Subject: AP1000 COL Standard Design Change Resubmittal of Sensitive and Non-Sensitive
Versions of APP-GW-GLR-016, Revision 0

APP-GW-GLR-016, Rev. 0

“AP1000 Pressurizer Design”

AP1000 Pressurizer Design

Figure 3.8.3-6 (Sheet 4 of 4)

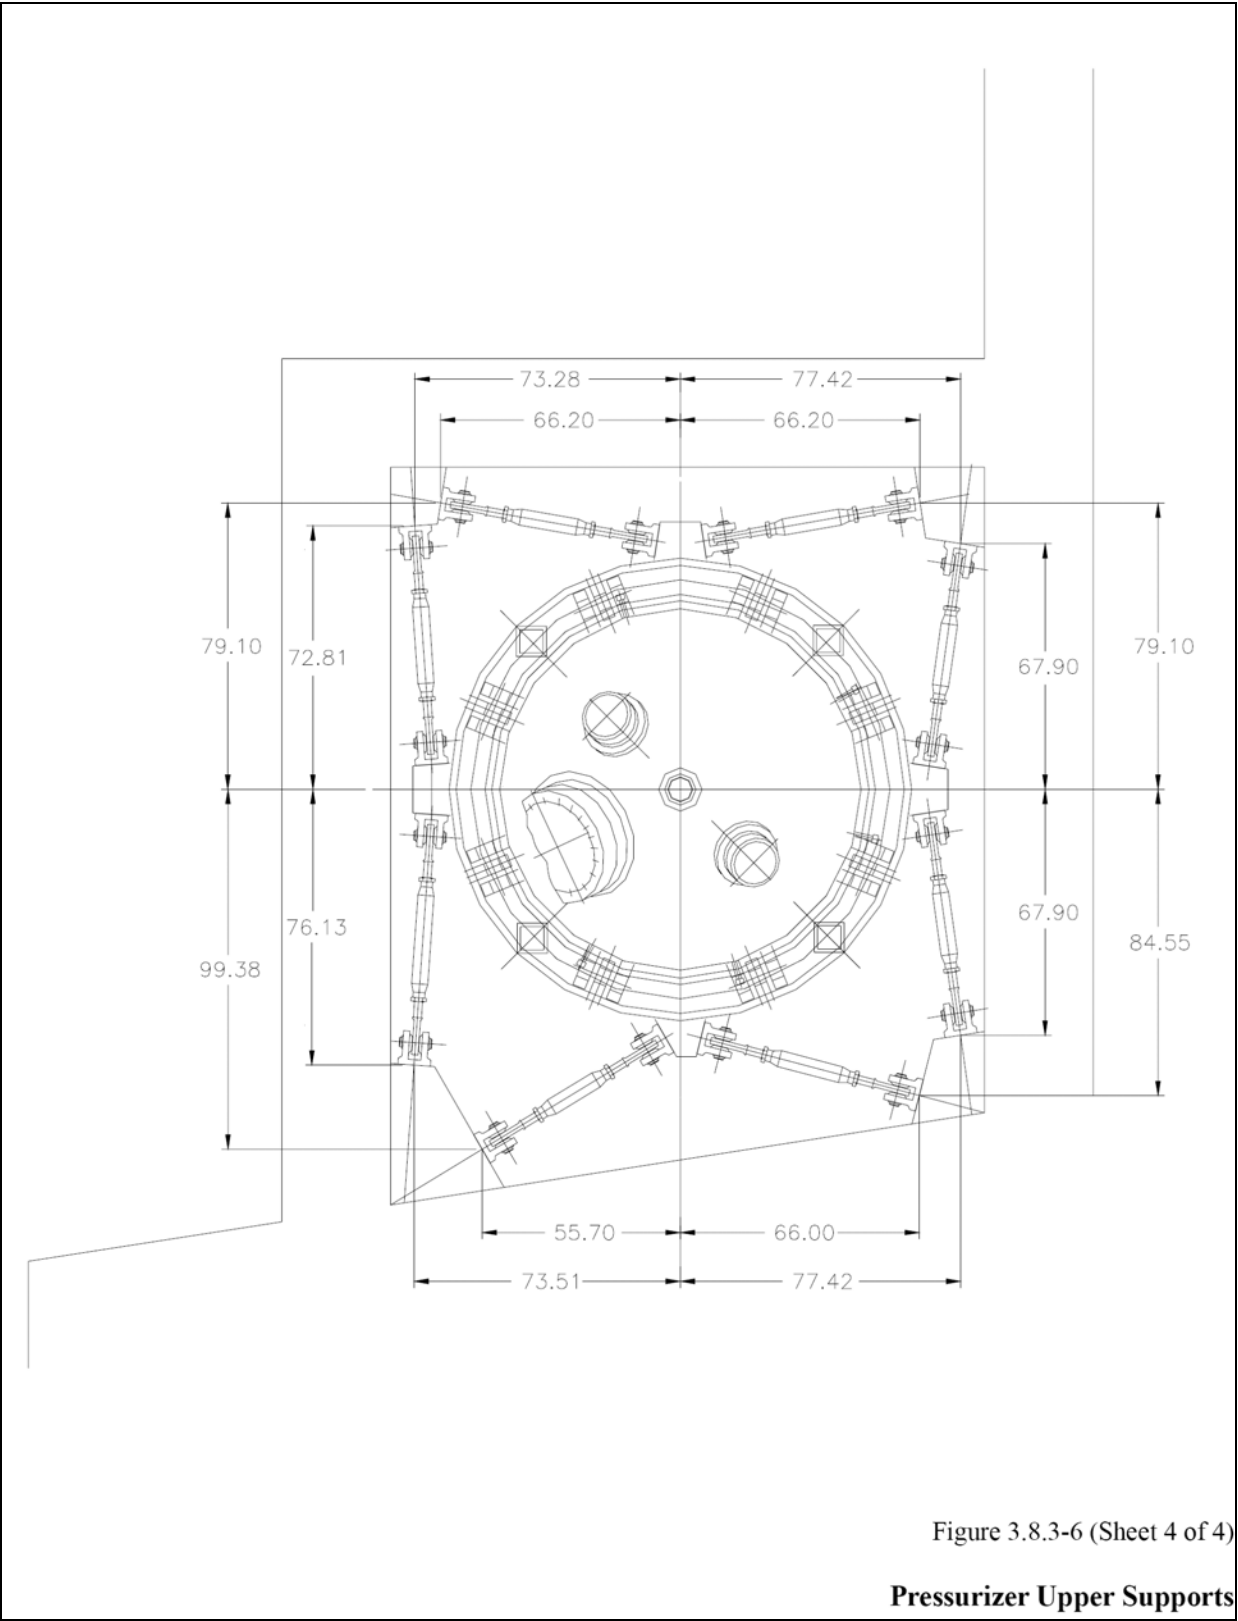
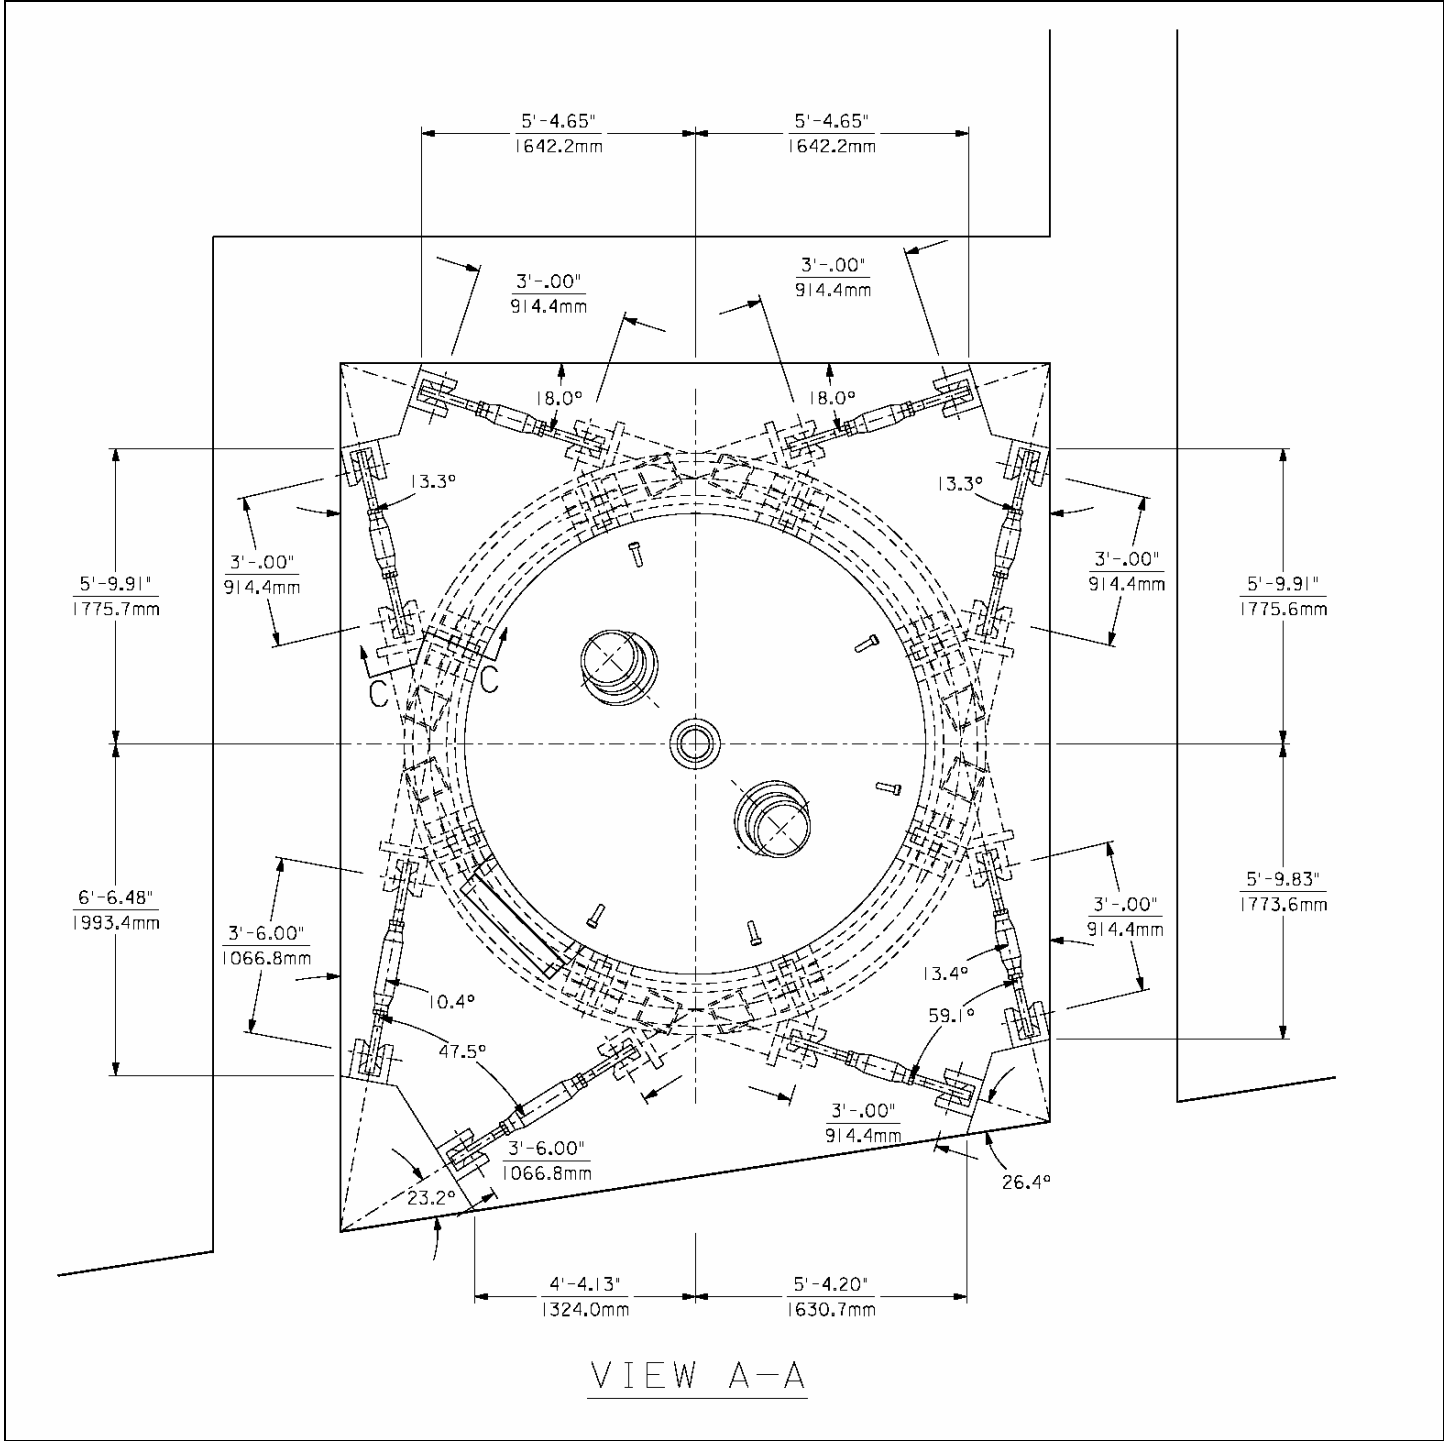
The ring girder rests on top of the pressurizer upper lateral/ADS support brackets. The elevation at the top of these brackets changes from El. 164'-1.36" to El. 152'-3.00". Also, the attachment point elevation of the sway struts to the ring girder will change from El. 164'-11.36" to El. 153'-0.00".

The attachment point of the support struts to the ring girder has been moved so that the support struts intersect at the center of the ring. For the original design, the support struts intersected the ring girder at the external edge. This configuration reduces the moments in the ring girder.

The upper lateral support struts elevation will be lowered from the current El. 164'-11.36" to El. 153'-0.00" to accommodate the change in pressurizer dimensions. The support struts are shorter and the angles formed at the struts with the reinforced concrete wall are shallower. However, the basic concept of a support ring and 8 support struts has been maintained. The DCD figure, 3.8.3-6 (Sheet 4 of 4) was altered to show the pin to pin dimensions instead of the bracket to centerline dimensions in the previous drawing. These dimensions were deemed more appropriate for this figure.

Figure 5.1-3

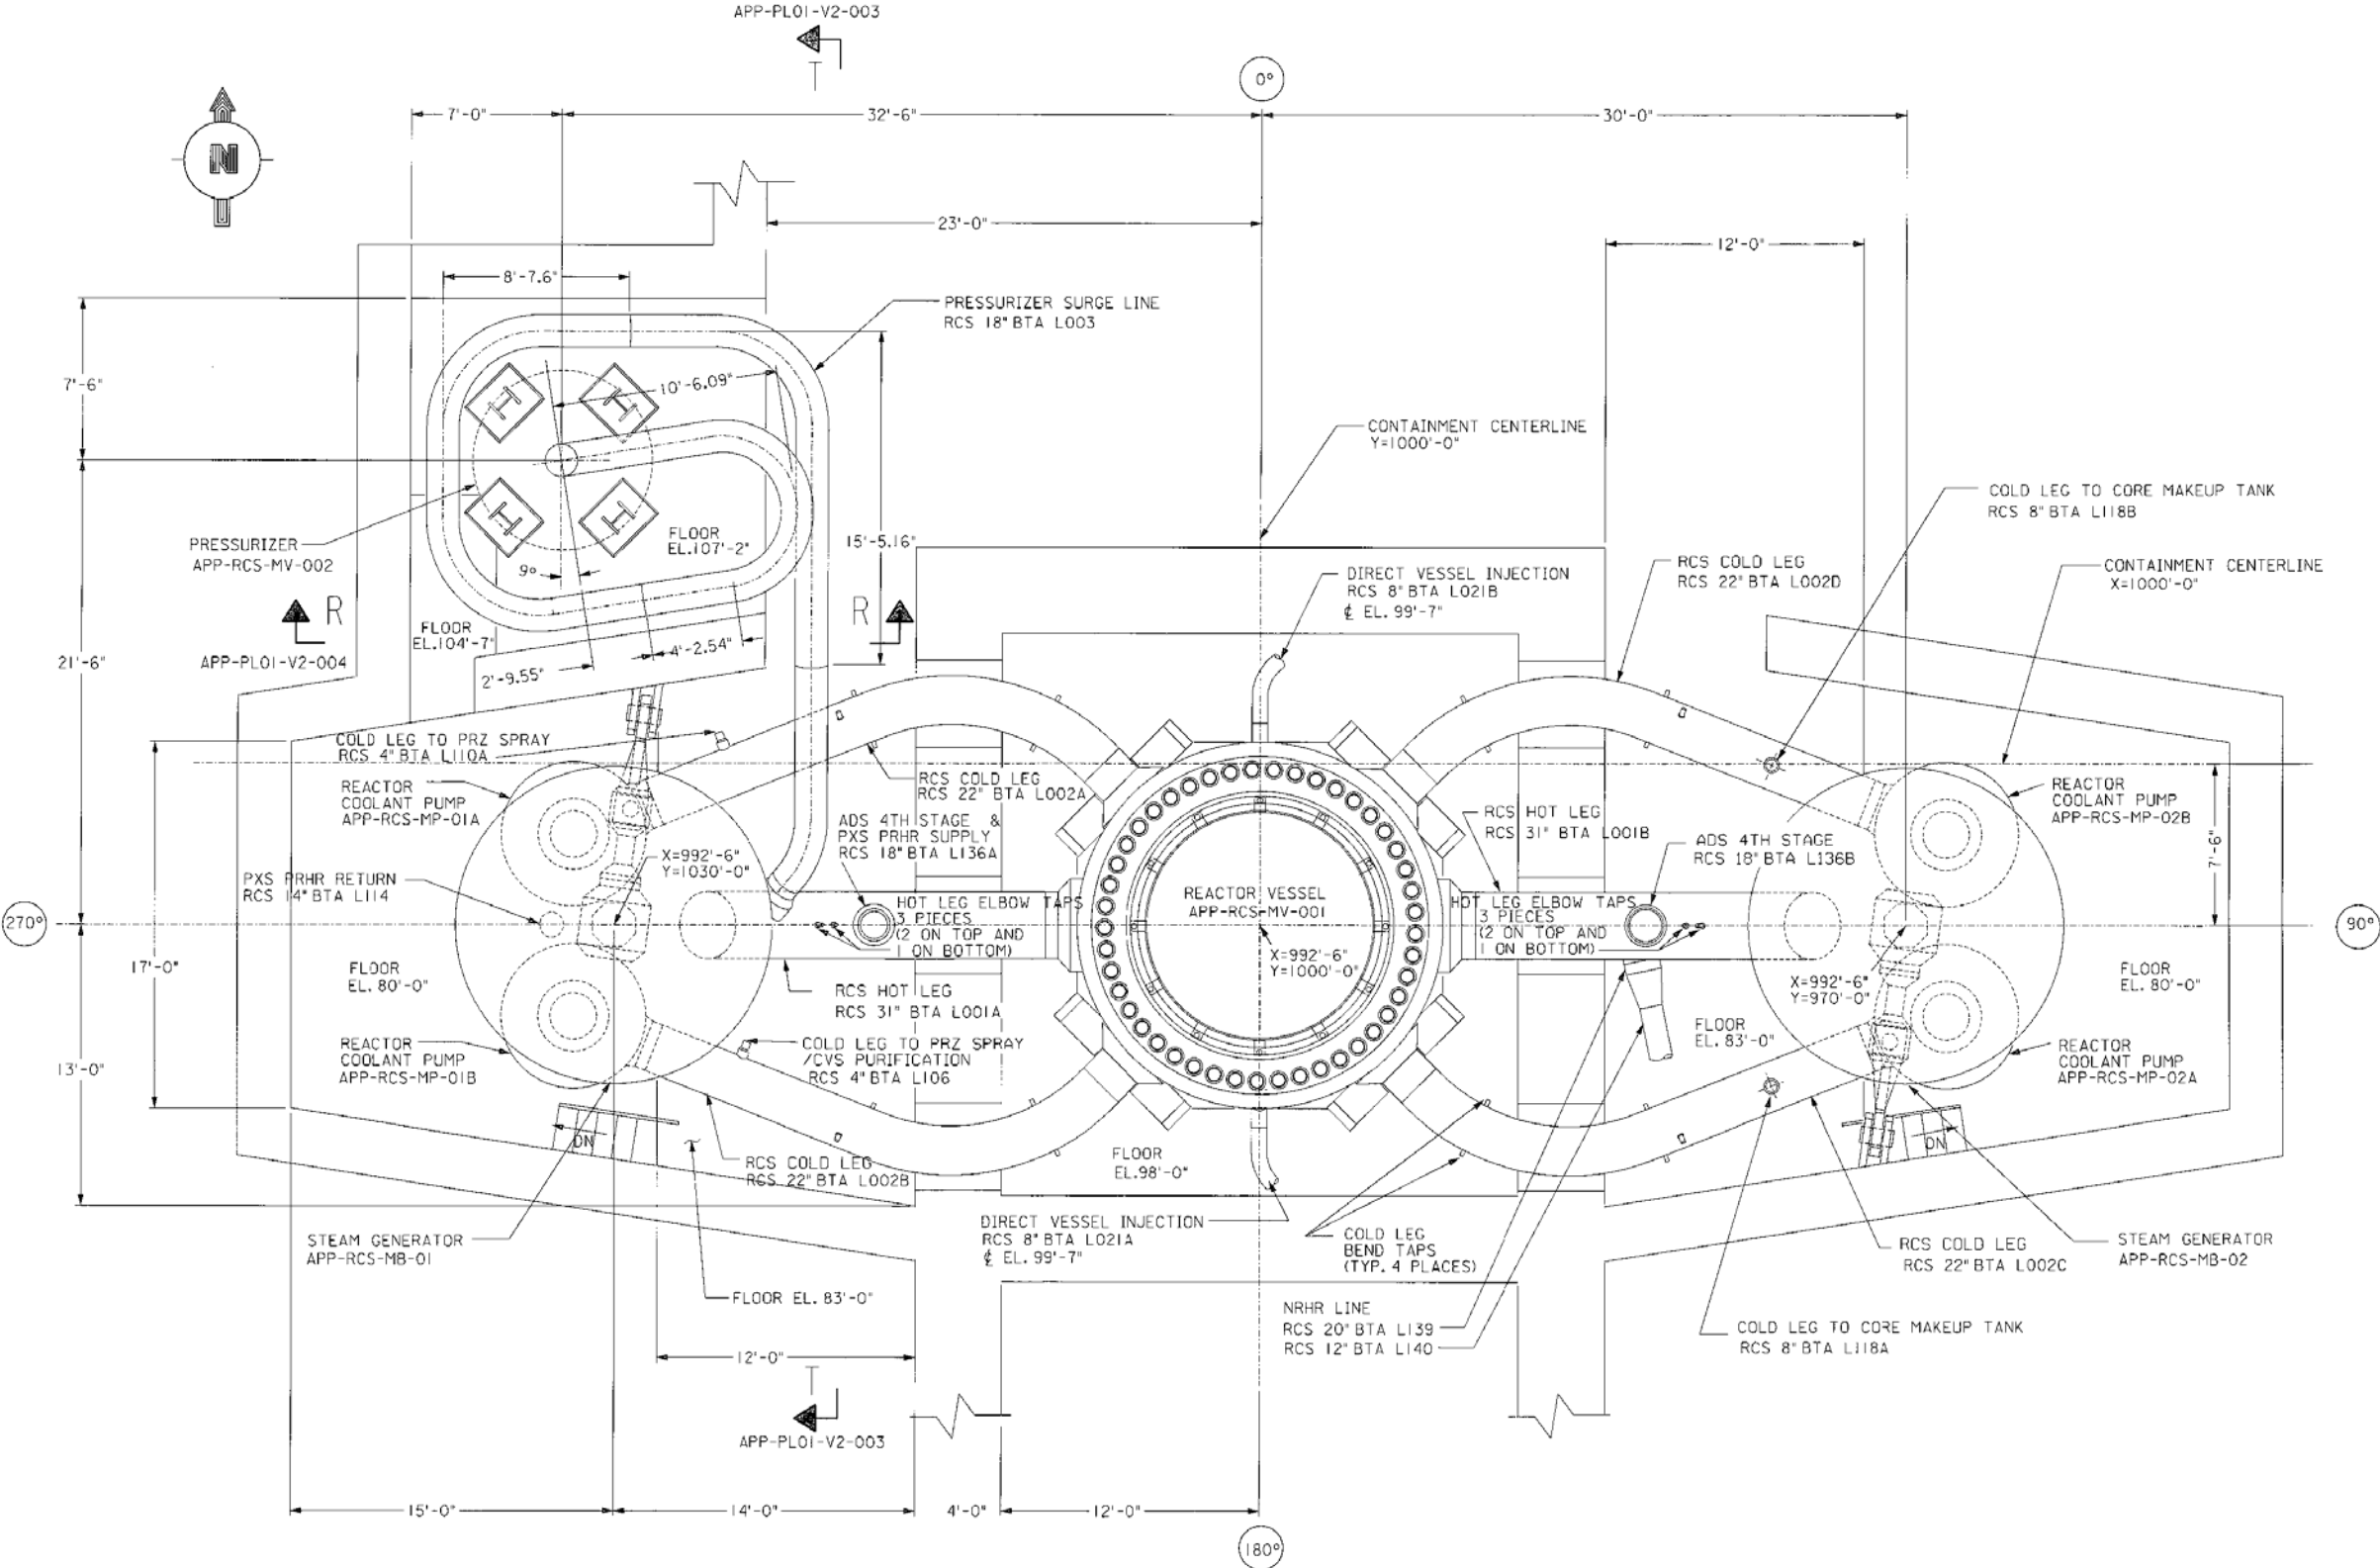
Figure 5.1-3 currently provides sections T-T and R-R which reference AP1000 drawings which are not included in the DCD. These sections were removed from the figure due to the references to these drawings.
